REMARKS

Docket No. 0513-1175 Appln. No. 10/582,350

FIG.5

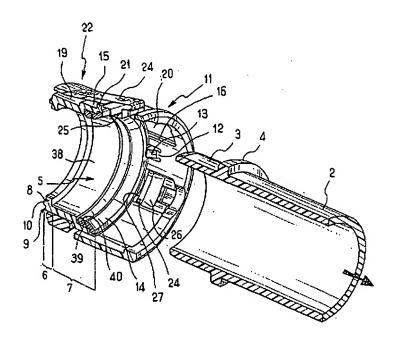
The drawings have been objected to as missing a lead line for reference element "1" in Figure 4 and for not having brackets or dotted lines to designate a complete figure in Figures 5 and 6. The comments in the Official Action have been

The present invention pertains to a quick coupling device that is illustrated, by way of example, in Figure 5 of the application, which is reproduced below.

As is set forth in claim 10 of the present invention, the device includes a tubular body (5) having a connection section (7) arranged to receive in a leaktight manner at one end

(3) of a duct (2). A retaining member (22) mounted on the body possesses tabs (24) that are elastically deformable between a first state of gripping an outer bead (4) on the end of the duct (2), and a second state of releasing the bead. The retaining member is mounted on the body to turn around a central axis of the body between a free deformation position in which the tabs can deform between the first and second states, and at least one holding position in which the tabs cooperate with a surface (20, 21) that is secured to the body and that holds the tabs in one of the first and second states.

That is, the present invention sets forth a quick coupling device that has a retaining member turnable around a central axis of the body of the device. McELROY et al. do not have this feature.

considered, and the drawing figures have been appropriately amended.

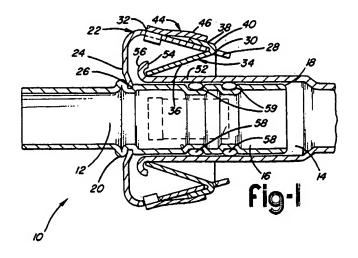
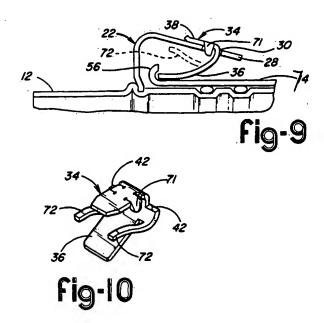
McELROY et al. pertain to a quick connect coupling. The Official Action refers to Figures 1, 9 and 10 of McELROY et al., which are reproduced below.

At page 6 the Official Action asserts that the Retaining members (36) of McELROY et al. are deformable around an axis perpendicular to the central axis of the body (24).

However, in McELROY et al. the retaining members are not pivotable in a holding position in which the retaining member is maintained by a body surface either in its releasing state or it gripping state.

McELROY et al. therefore do not disclose each and every element of claim 10 of the present invention. McELROY et al. accordingly do not anticipate claim 10 of the present invention. Claims depending upon claim 10 are patentable over McELROY et al. for at least the above reasons.
